**RE: Cloverleaf Self Storage
Modification/Waiver Request Letter
Mount Joy Township, Lancaster County
Project No. 2023108-001**

Re: Cloverleaf Self-Storage
Preliminary/Final Land Development Plan
Township Permit No. 23-12-FLDP
LCEC Project No: 25-162

**PROPOSED MOTION FOR THE FINAL LAND DEVELOPMENT PLAN
FOR CLOVERLEAF SELF-STORAGE
M.J.T.P.C. File # 23-12-FLDP**

UNDERDRAIN DETAIL

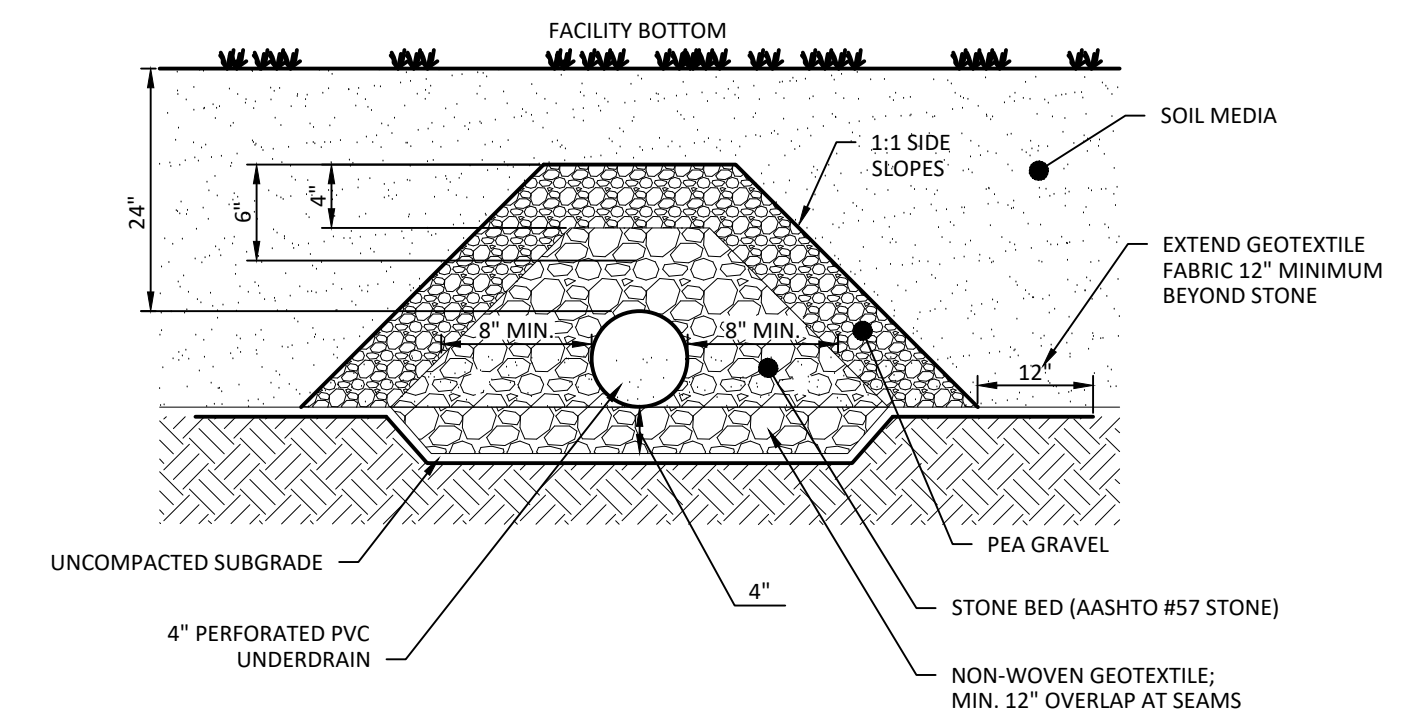
41. The "six" inch dimension shown in the Underdrain Detail shall be revised (113-43.J(5)).

STORMWATER MANAGEMENT FACILITY 1 (EXTENDED DETENTION) DETAIL

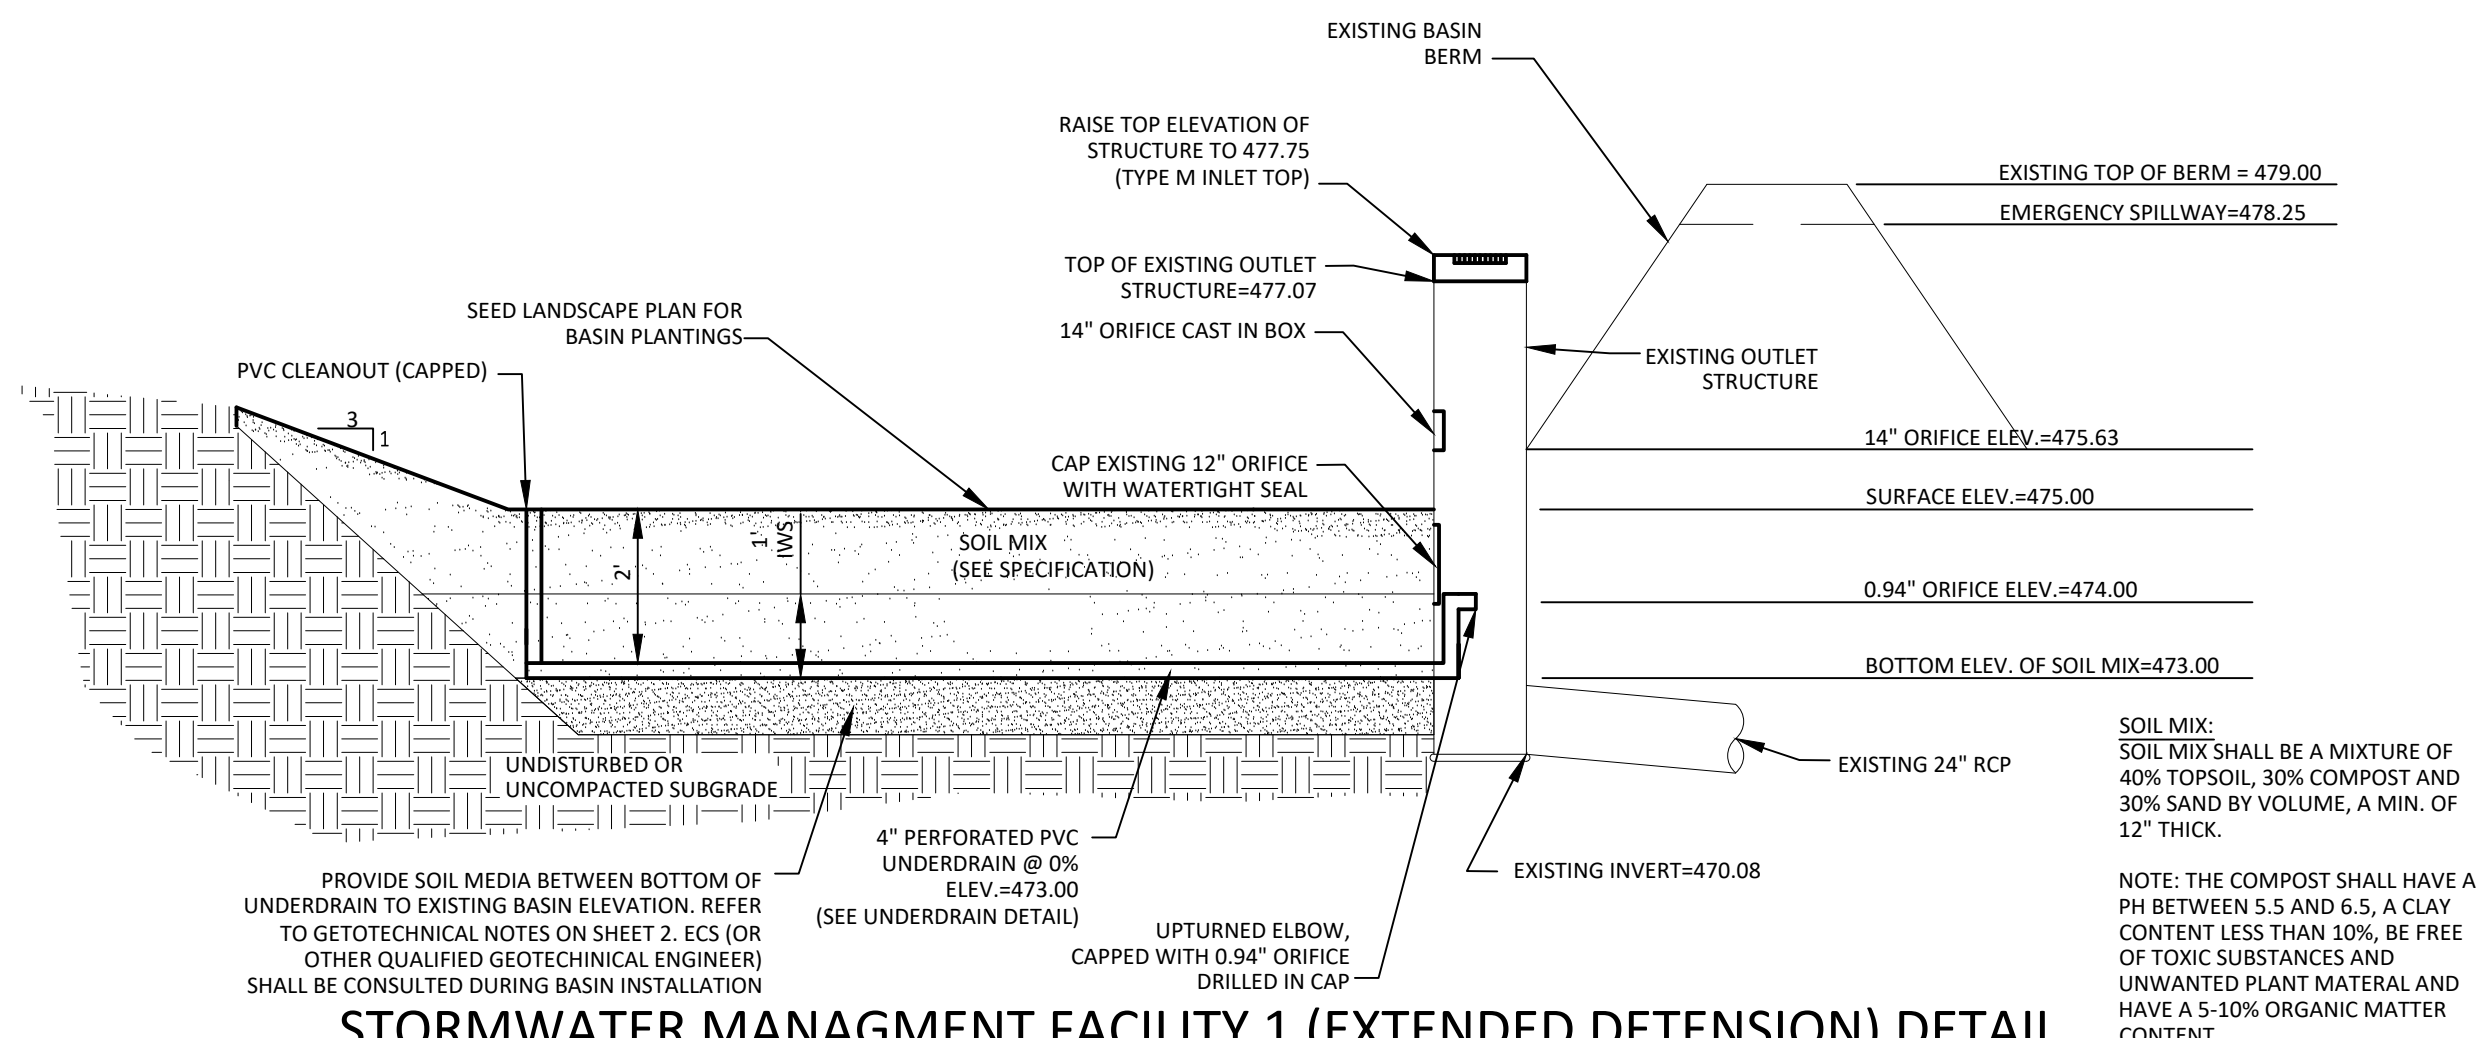
39. The diameter of Orifice [C] and the crest elevation of Weir [A] shown in Pond Report No. 3 are inconsistent with the diameter of the orifice and crest elevation of the outlet structure shown in the Stormwater Management Facility 1 (Extended Detention) Detail (113-43.J(5)).

EMERGENCY SPILLWAY DETAIL

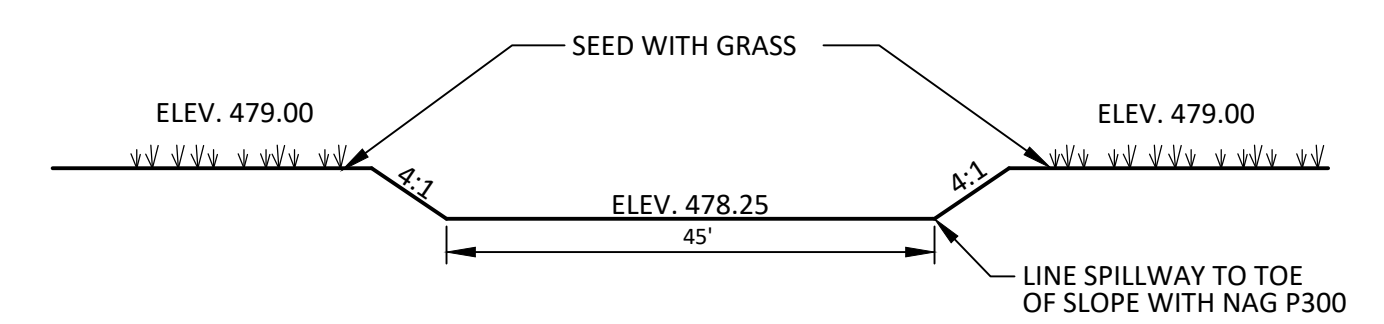
40. The crest length of Weir [B] shown in Pond Report No. 3 is inconsistent with the length of the spillway shown in the Emergency Spillway Detail (113-43.J(5)).

ENDWALL TRASH RACK DETAIL

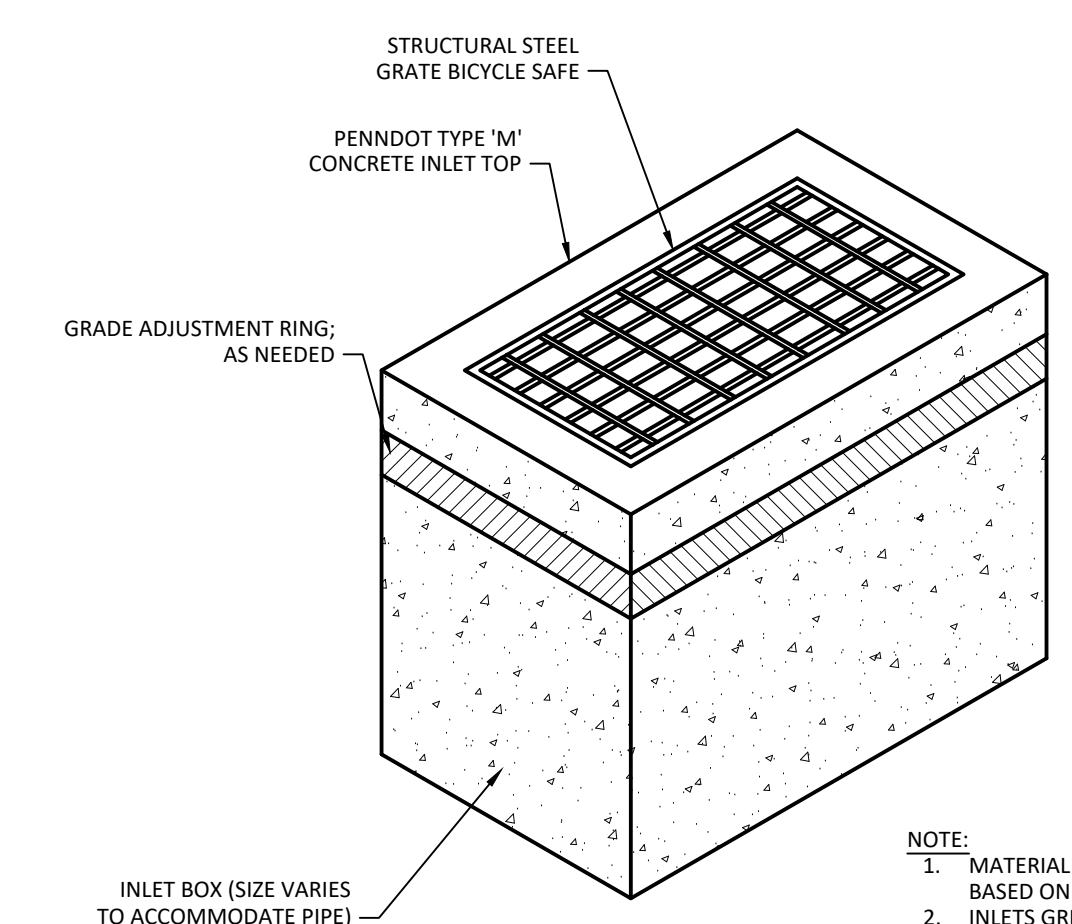
36. The locations of the proposed Endwall Trash Racks shall be shown on the plans (i.e. provide for the existing endwall) (113-37.C(9)(a)).
37. The landowner shall execute the final documents prior to final plan approval (113-41.B).
